316 (b)
Once Through Cooling
Deadline: 9/15/06 5pm

September 15, 2006

Re: Comments on "Proposed Statewide Policy on Clean Water Act Section 316(b) Regulations"

Figure 1. Retrofit Cooling Tower Options for California Nuclear Power Plants

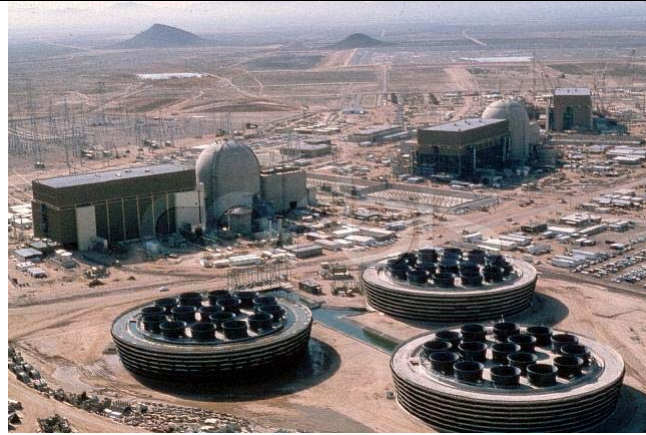
Not necessarily. Wet towers can be equipped with plume abatement technology to minimize or eliminate vapor plumes. This is now standard practice in California for power plant cooling towers in urban areas. See Figures 1 and 2.
